DUE DILIGENCE STUDY FOR NORTH COUNTRY SYSTEM REINFORCEMENTS IN 2010, SYSTEM STUDIES REVIEW

JOB/PROJECT TITLE **Due Diligence Study for North Country System Reinforcements in 2010, System Studies Review**

CLIENT ORGANISATION **Western Power Electricity Networks Corporation**

DOCUMENT ID NUMBER **E203323/P204290/RP001**

Figure 4-1 Network configuration for option 2a

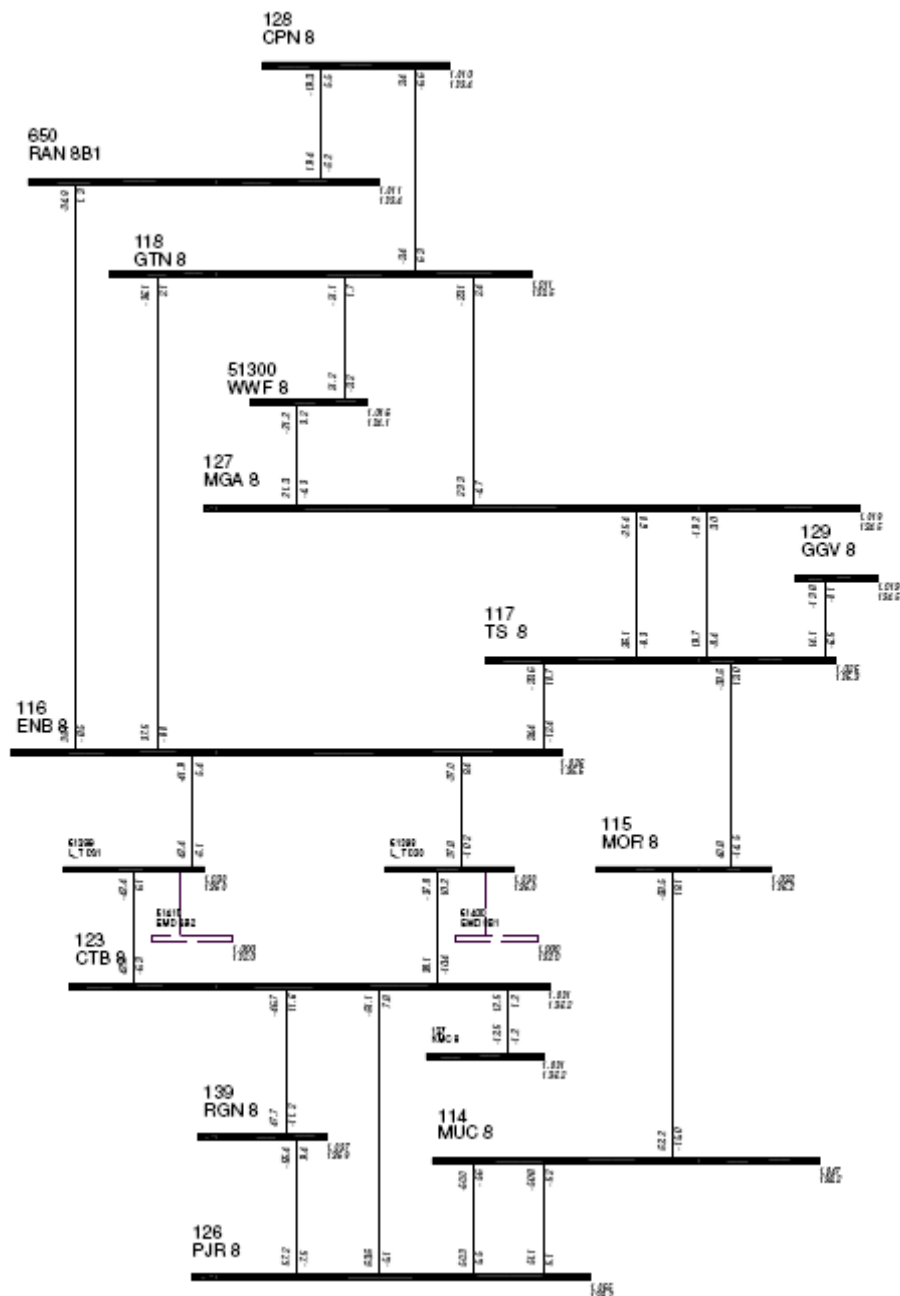
Based on the studies done by Western Power, reinforcement option 2a is only a bridging solution until the year 2014. Therefore in this study the base case given by Western Power for the year 2014 is considered. Studies show that without any dynamic reactive support, option 2a may not be viable due to steady state voltage instability. Geraldton appears to be the most appropriate place to connect any reactive support device due to the large concentration of load of that area.

Based on the reactive reserve studies, an SVC and capacitor bank of 55MVar minimum capacity is needed at the Geraldton 132kV bus in order to satisfy the zero reactive margin limits in the planning criteria. Therefore, the additional reactive support devices need to be designed such that the combination of reactive support devices can provide 55MVar of dynamic and static reactive support even when the largest reactive support device is switched off as required by the Technical Code.

To comply with the reactive reserve and TVR requirements, a combination of fixed capacitor bank, SVC and STATCOM would be the most cost effective solution. One such combination is:

- 20MVar STATCOM
- 30Mvar fixed capacitor bank x 2
- 10 MVar SVC

In order to satisfy the reactive reserve criteria, the above reactive support devices need to be installed on separate circuits to cater for loss of the most critical reactive device.

Figure 4-2 Reactive margin for contingencies with 55MVar support at GTN

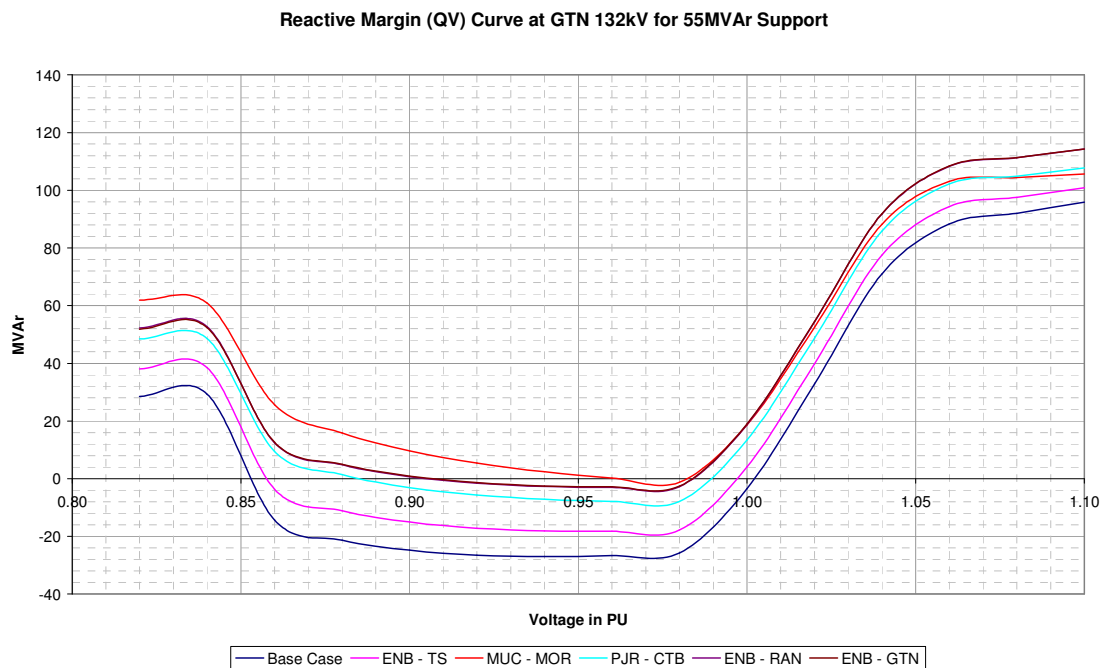
The most critical contingency for the reactive reserve calculation is the outage of the Muchea to Moora 132kV line. The reactive reserve results for the various contingencies are shown in the Figure 4-2.

Figure 4-3 Voltage at CPN for MUC – MOR contingency

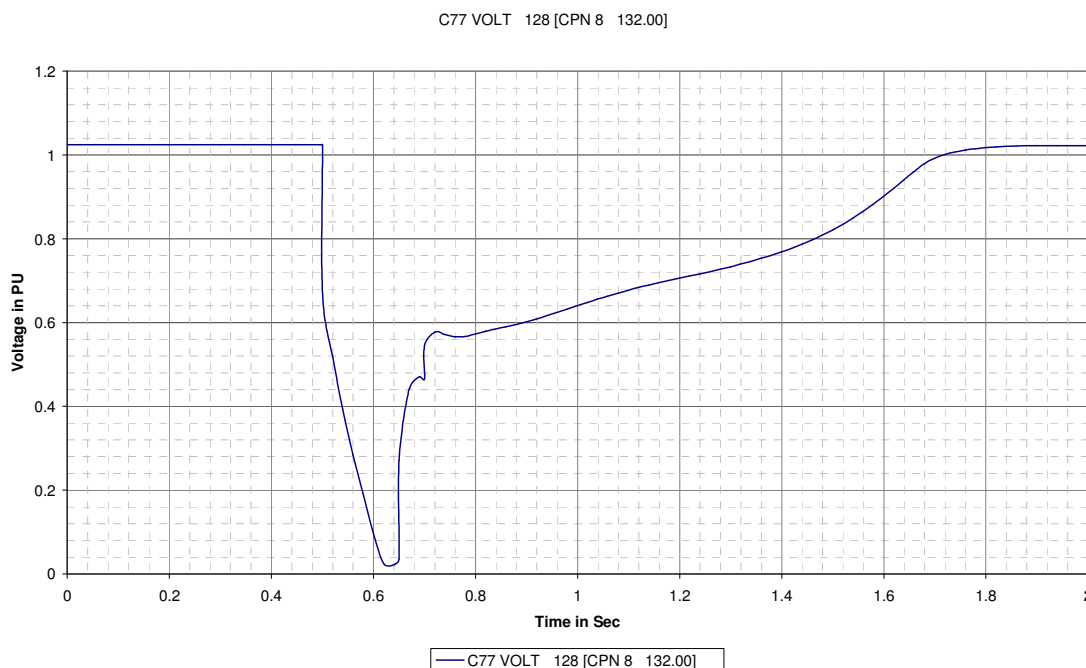
Based on the dynamic studies, the following dynamic reactive support is needed to comply with the TVR code requirement at the Chapman 132kV bus.

- a. 65MVar Static VAr Compensator (SVC); or
- b. 40MVar fixed capacitor bank with 20MVar STATCOM

Figure 4-3 shows the voltage recovery at the Chapman 132kV for above option (b) for the MUC – MOR line fault/outage.
